# MEMORANDUM

RE: **BUILDING DEMOLITION REVIEW**  
**197 Seymour Street (MAP 5, Lot 105)**  
**Circa 1934, one-story wood framed residential structure and 1984 two story addition.**

Subject: Inspection of Residential Building and Garage  
197 Seymour Street, New Bedford, MA

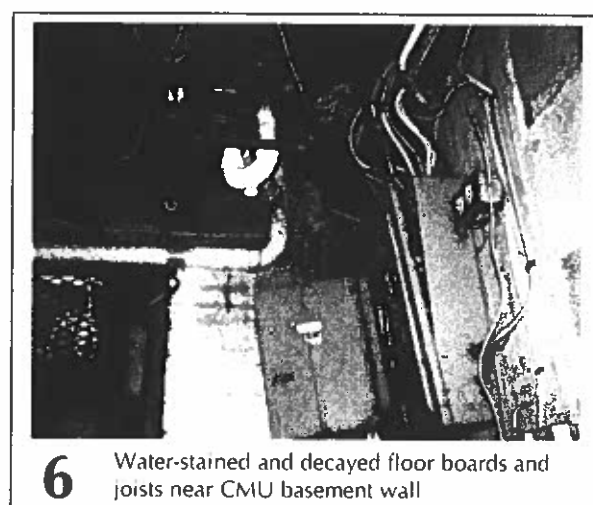
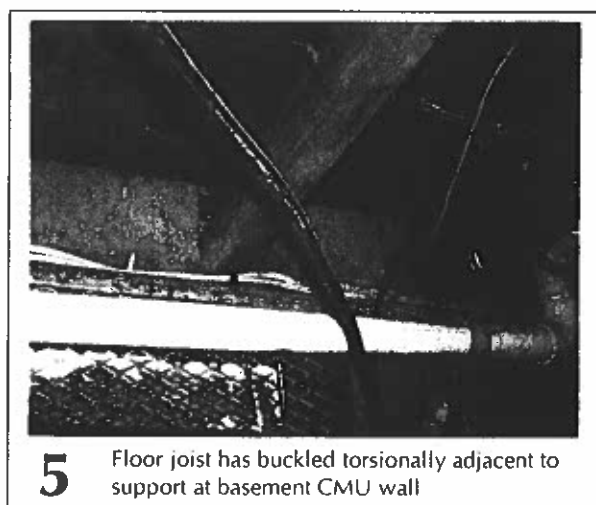
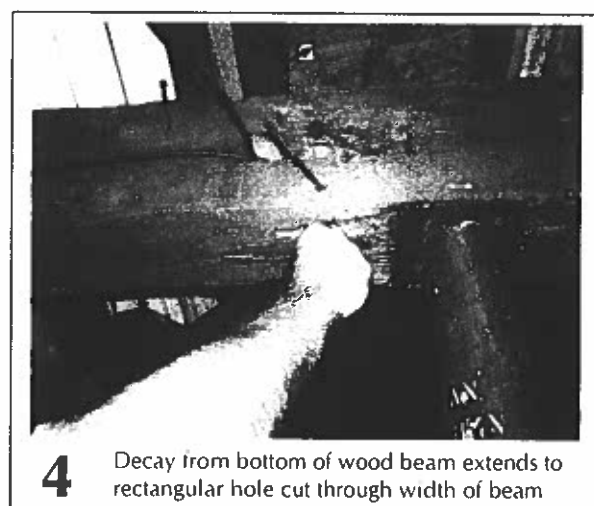
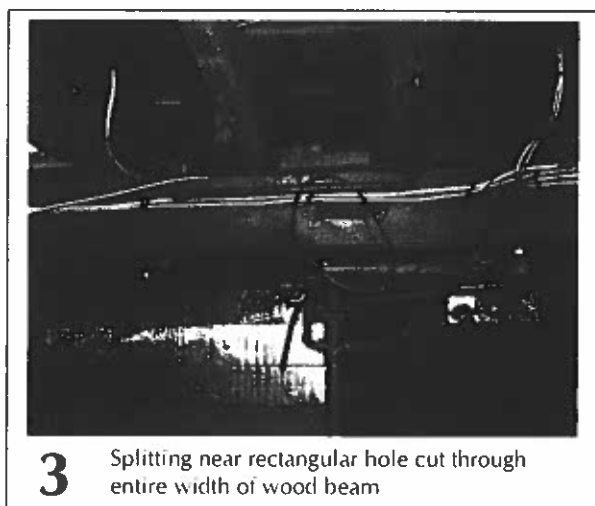
1. As shown and described in Photos 1 through 4 on Page 3 herein, the wood beam that supports the first floor joists in the basement of the front building ell has sustained various deterioration and damage. Some areas are decayed and split, while other areas contain rectangular holes that were cut through the entire width of the beam. Such a significant reduction of the load capacity of this approximately 30-foot long beam will likely necessitate that it be replaced.

Due to conditions outlined above, it is not feasible to proceed with the work as is currently proposed and budgeted. Work required to replace the beam identified in Item 1 above will be extensive and correspondingly expensive, and it may prove to be the same for whatever work may be required for roof rafters and/or knee walls and/or floor joists as described in Item 2 above.

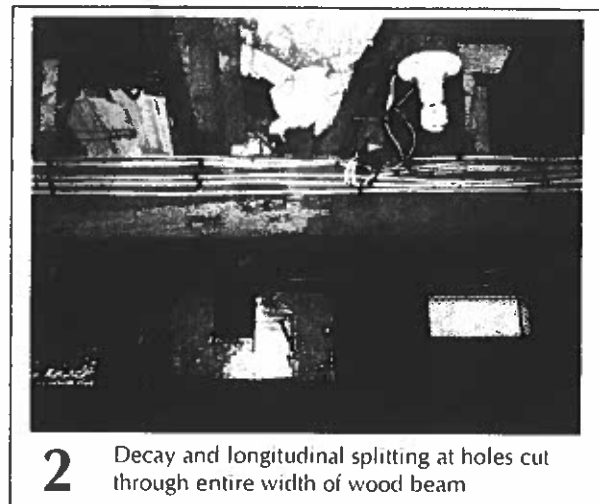
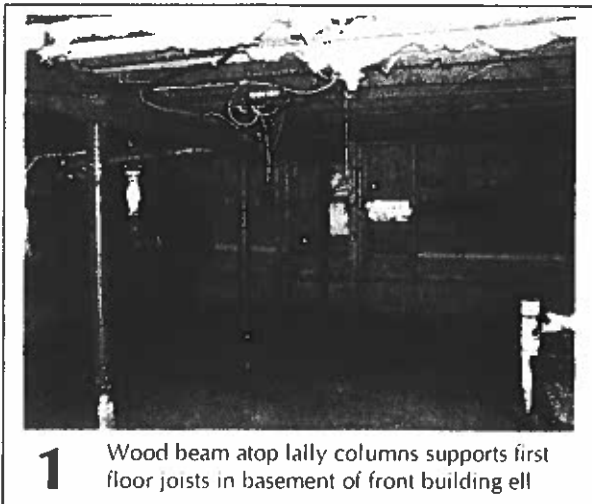
Photos 5 and 6 on Page 3 also show several joists and subflooring boards that must be replaced, which are representative of similar work elsewhere. All of this work will require engineering design and construction control in addition to the cost of construction.

**7** West bedroom or two located on second floor of rear building ell facing Northeast

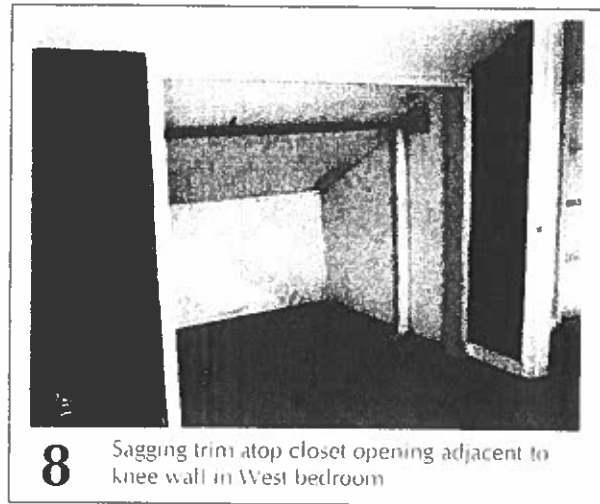
2. I have included Photos 7 through 11 on Page 4 herein to try to address what I anticipate may be problems with some structural components in the rear building ell that were inaccessible for inspection because they are concealed. The sagging curve of trim and wall above each of the two closet openings in the knee wall near the rear of the building indicates the possibility of problems with the load transfer along the load path between roof rafters and knee walls and second floor joists. Further investigation would be required, which would necessitate localized exploratory demolition and engineering calculation to analyze components.
